**From:** City Planning <cityplanning@ccc.tas.gov.au>  
**Sent:** Thursday, 8 February 2024 4:59 PM  
**To:** TPC Enquiry  
**Cc:** O'Brien, Lauren; Planning; Mat Clark  
**Subject:** PDPSPAMEND-2021-019004 Combined Scheme Amendment & Draft Permit - 30 Holland Crt, Howrah - Response to TPC Directions

**Tasmanian Planning Scheme – Clarence**  
**Draft amendment PDPSPAMEND-2021-019004 and combined permit**  
**30 Holland Court, Howrah**

## **Attachment 1 : Response to Commission Directions of 27 September 2023**

**ATTACHMENT 4 - CCC Response to TPC Directions**

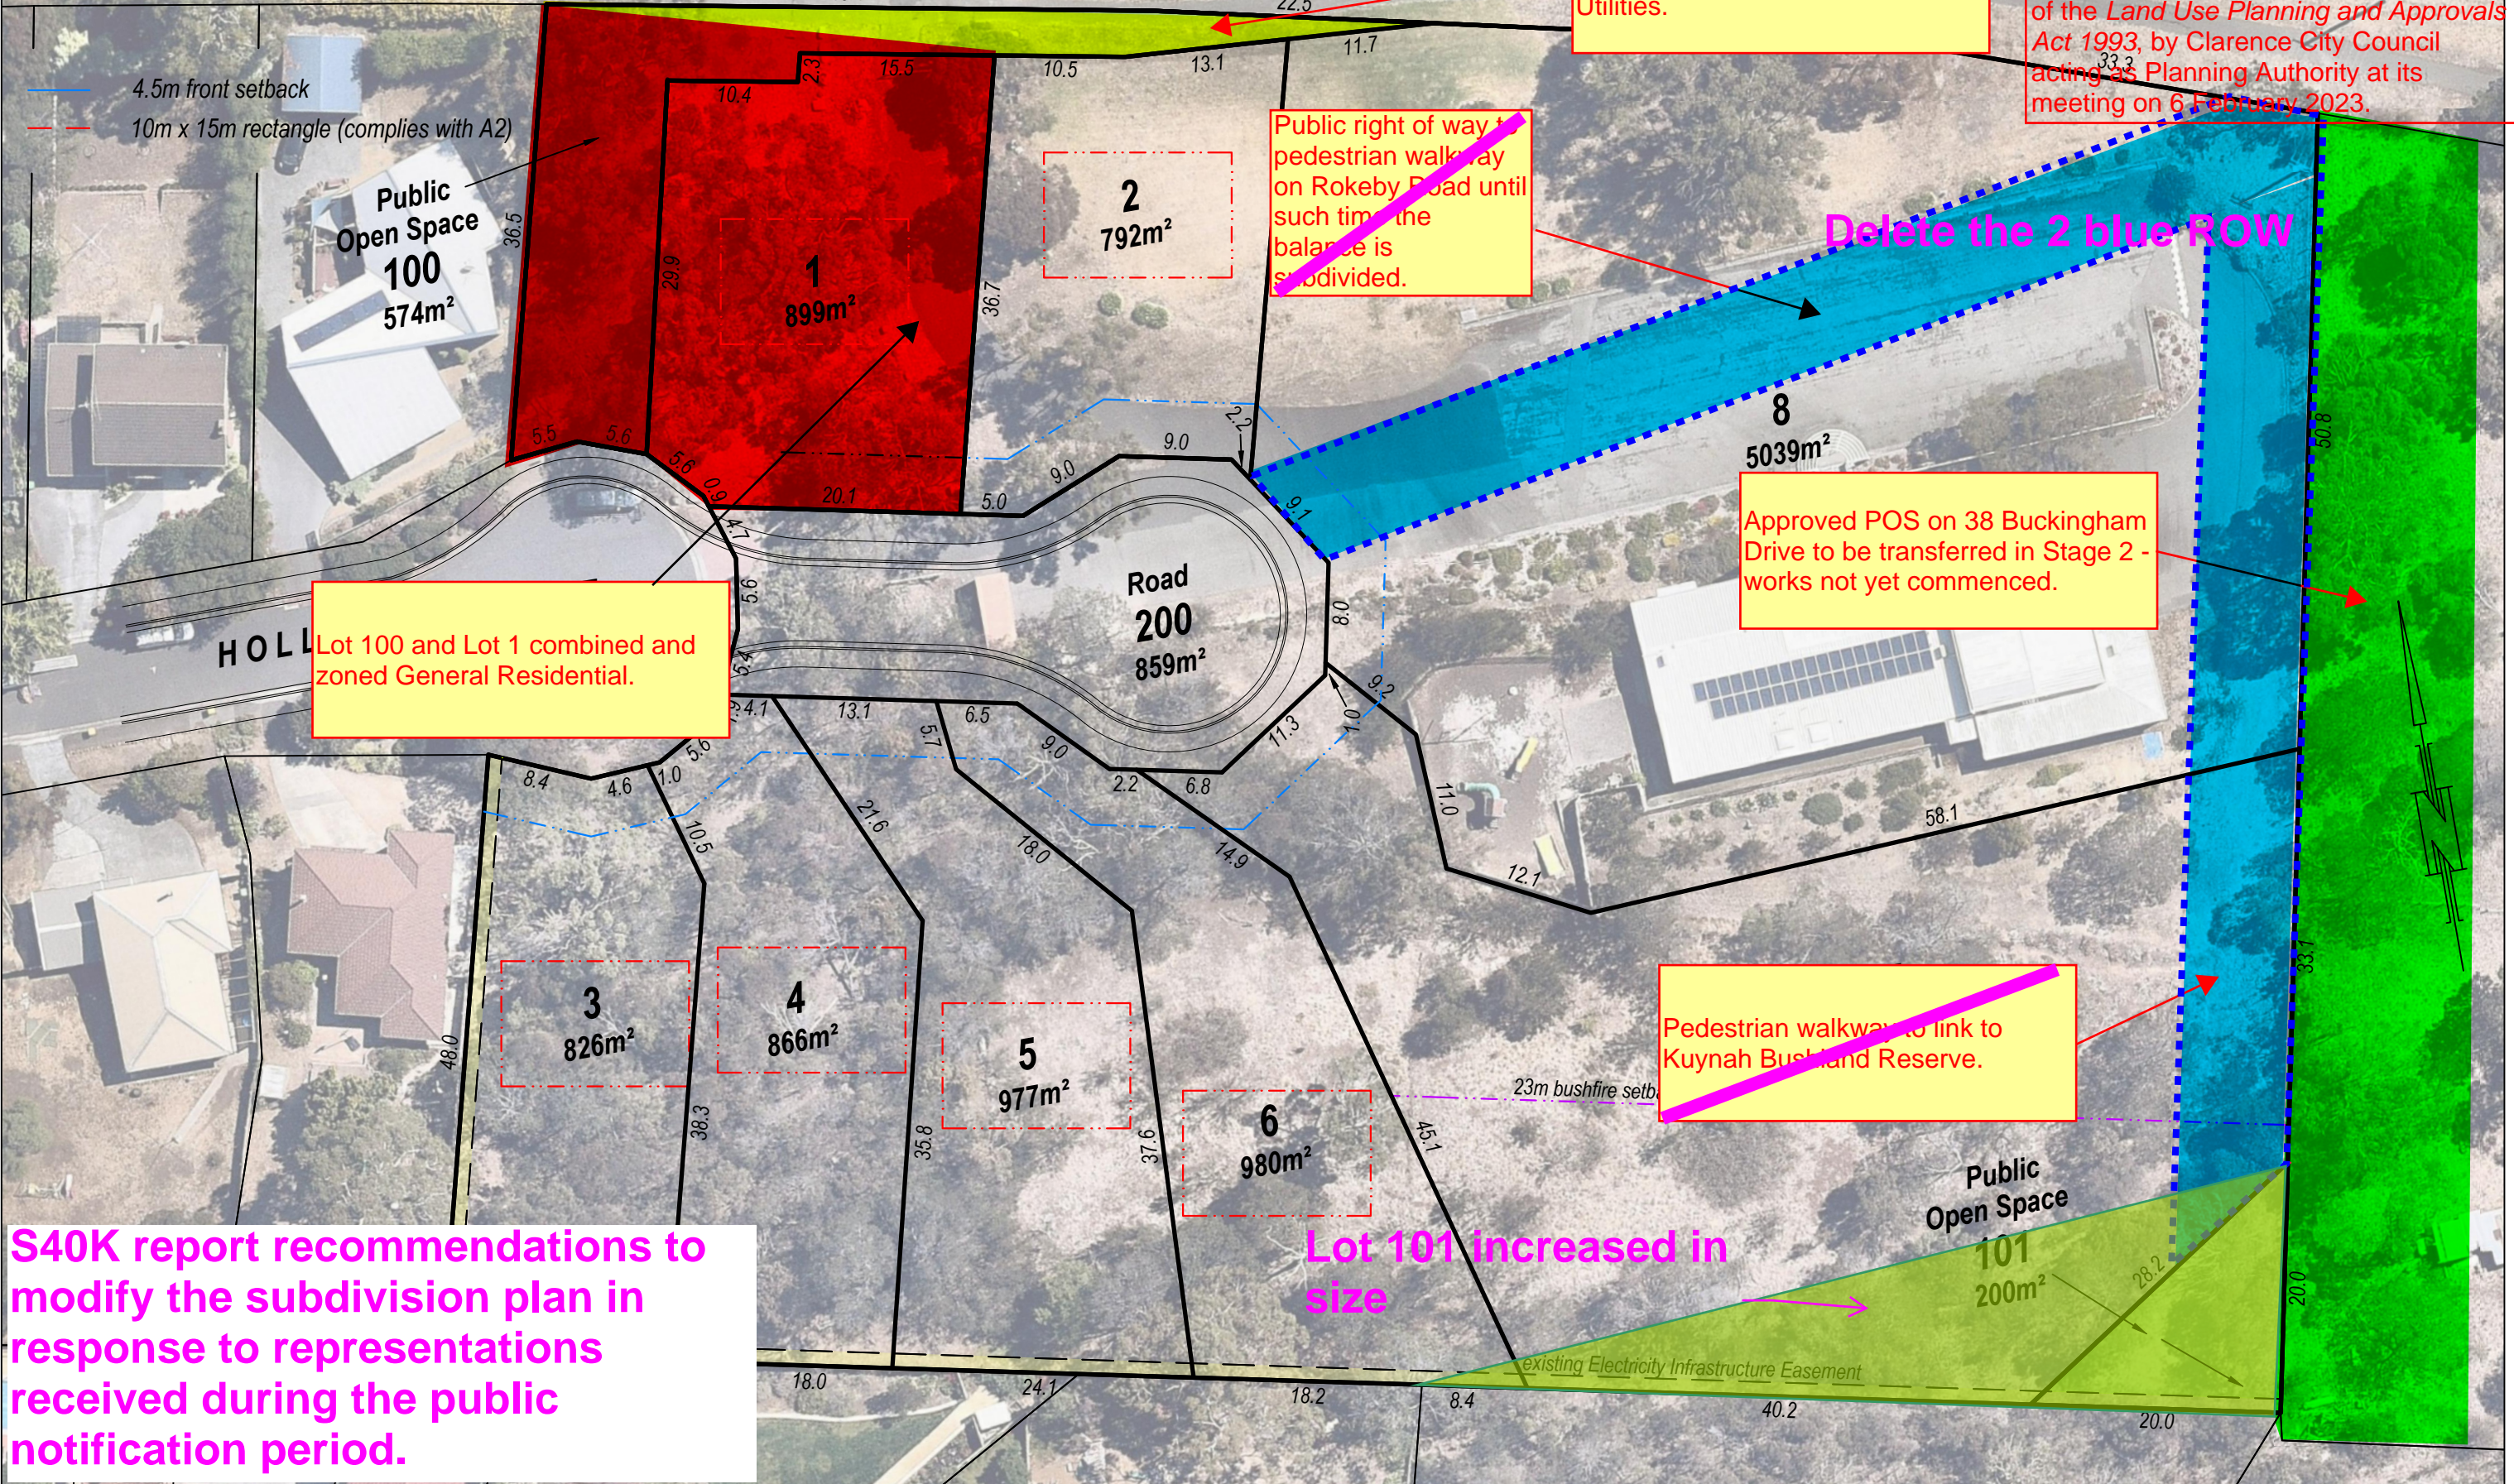
Based on the above, it is considered that the BHA and BHM Plan provided on 9 December 2023 do not demonstrate that the modified subdivision plan (Attachment 4) approved on 26 June 2023 either complies with or satisfies all applicable planning scheme provisions for the General Residential Zone, the Open Space Zone, the Natural Assets Code and the Bushfire Prone Area Code.

**ATTACHMENT 5**  
**Further queries and required modifications**  
**following applicant response to TPC**  
**Directions**

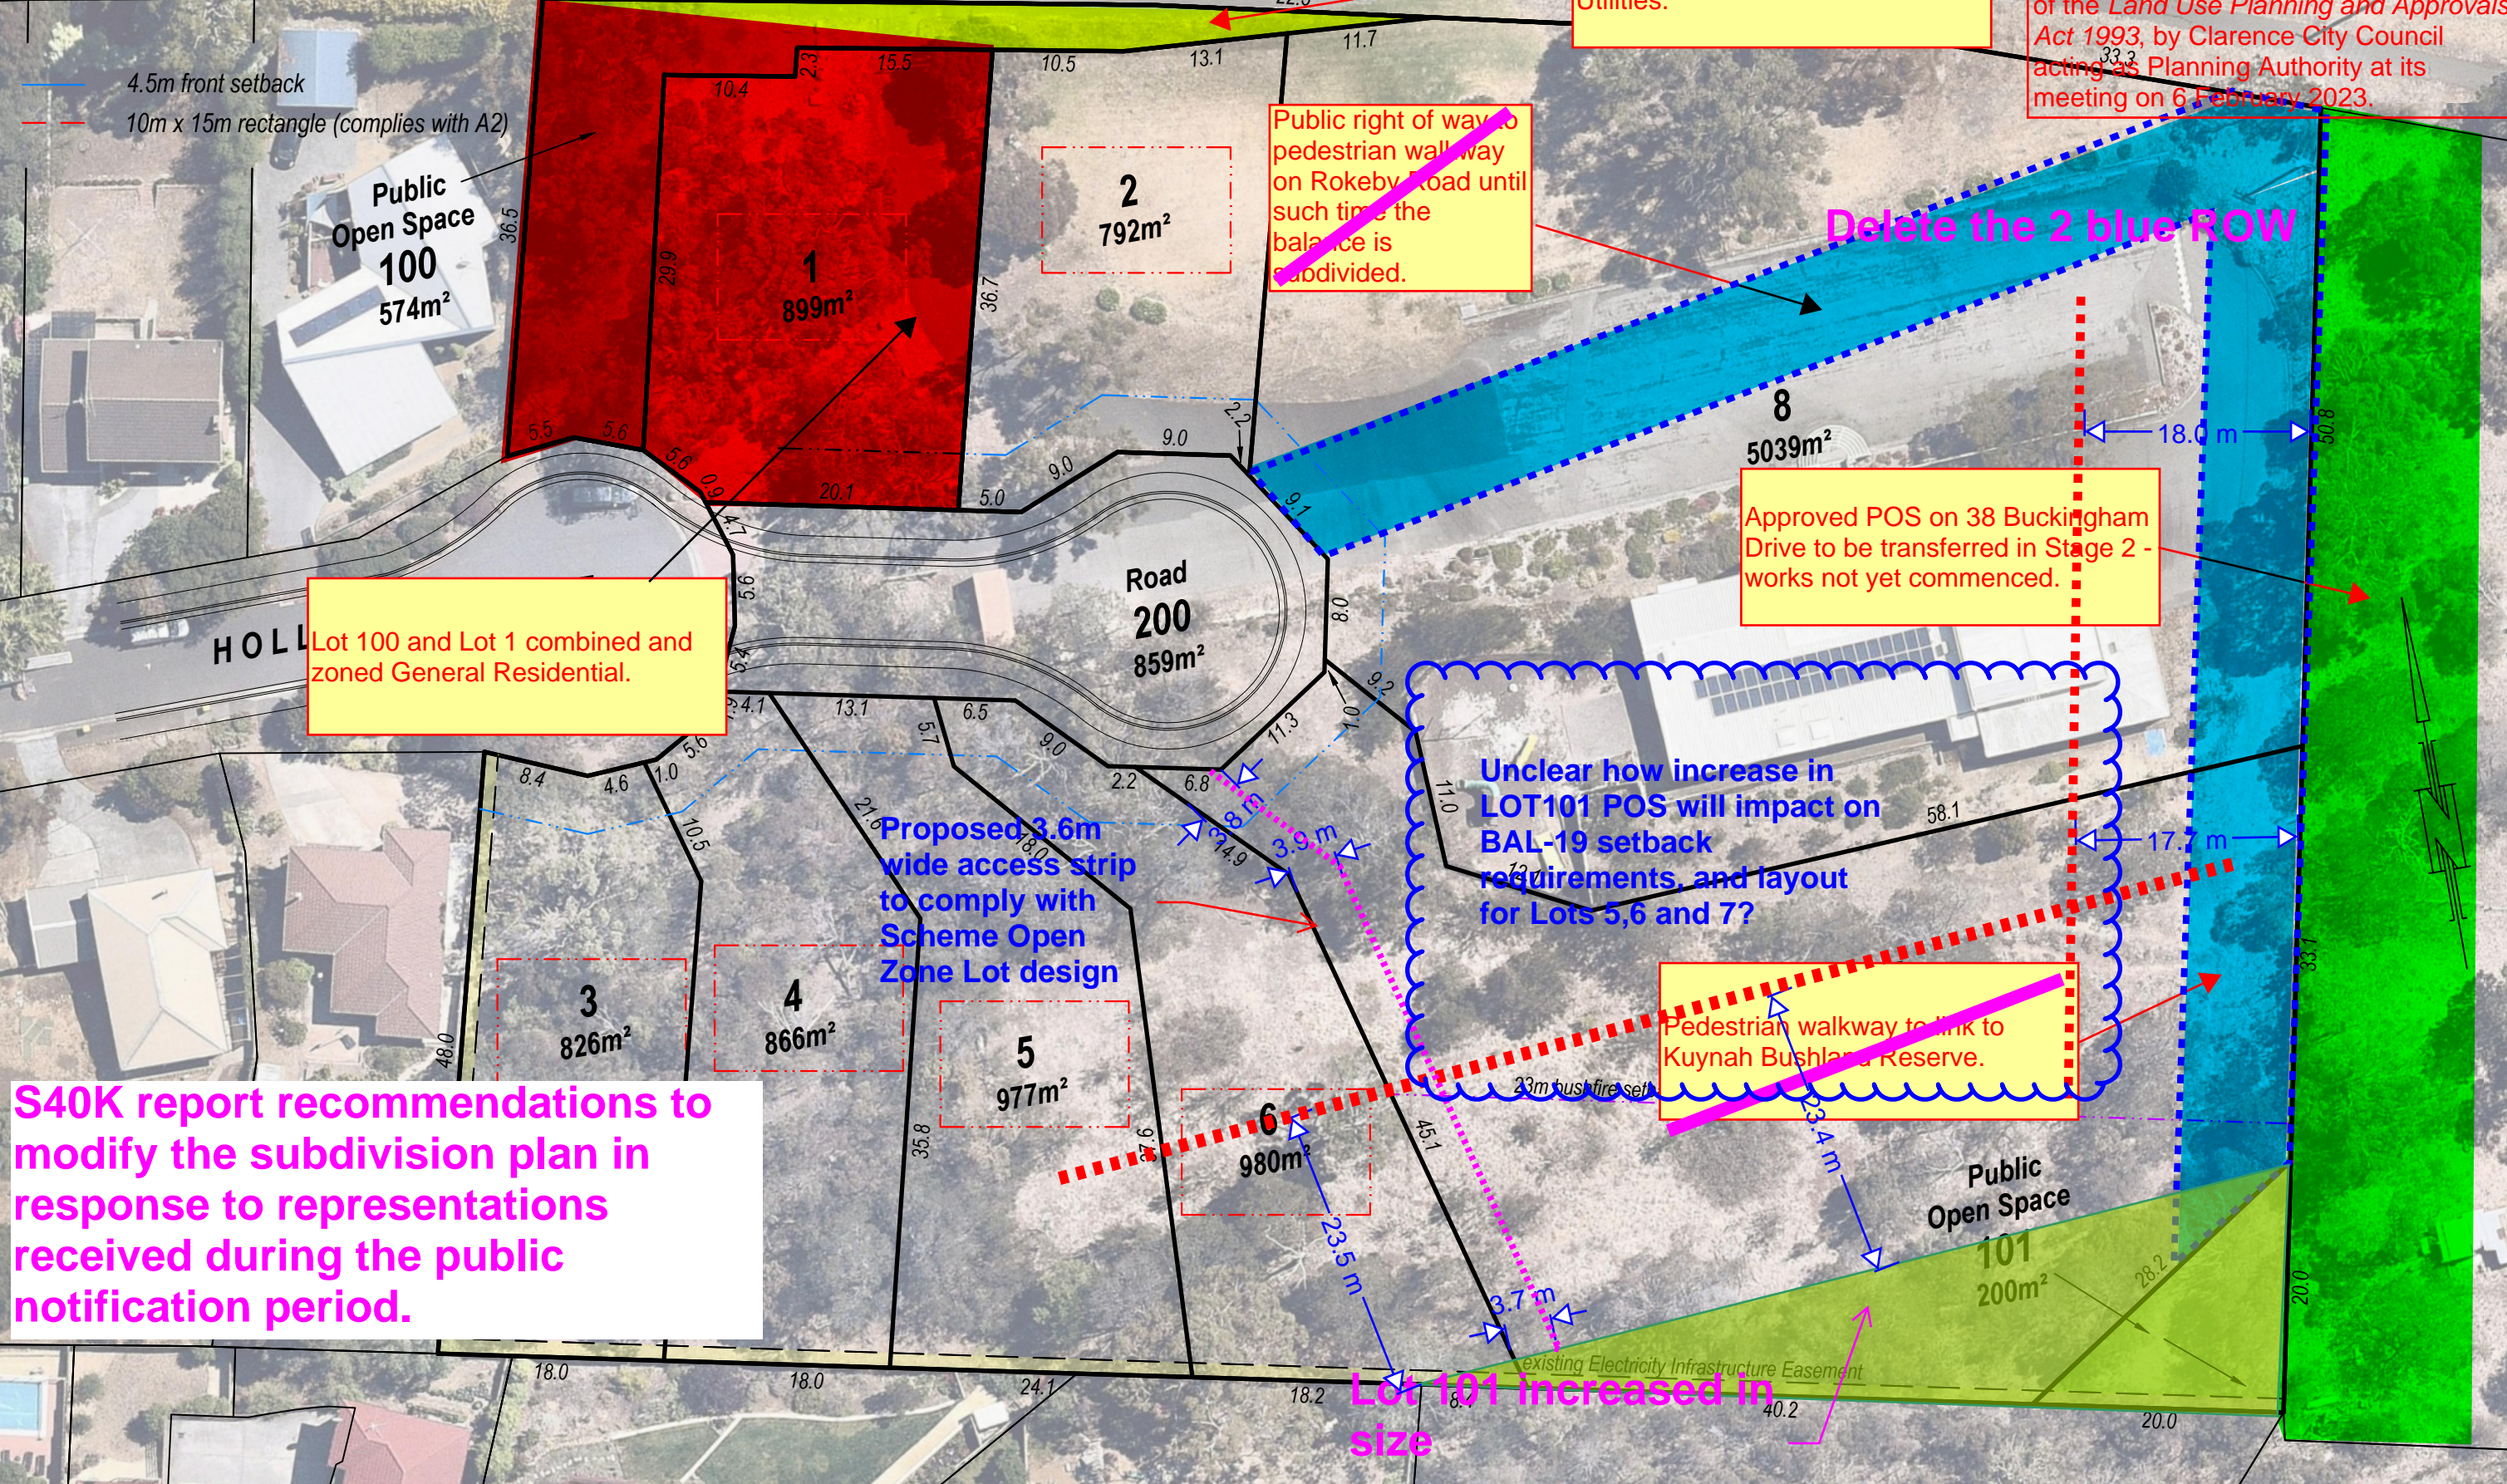
Therefore, for the modified plan of 26 June 2023 to comply with the scheme requirements, an amended plan is required to incorporate a 3.6m access strip from lot 101 to Holland Court. Attachment 5 has been marked up with an indicative access strip location. Alternate access via a right of carriageway was considered but is not preferred, due to the increased operational complexity of managing access over private land for council purposes.

Attachment 5 shows further mark ups of the 26 June 2023 modified subdivision permit to reflect the required changes to provide access to lot 101.

To resolve this issue, an amended plan showing the provision of a 3.6m wide access strip from the open space lot to Holland Court, is considered to comply with Acceptable Solution A2 (refer Attachment 5).

To resolve this issue, an amended plan showing the provision of a 3.6m wide access strip from the open space lot to Holland Court, is considered to comply with Acceptable Solution A3.
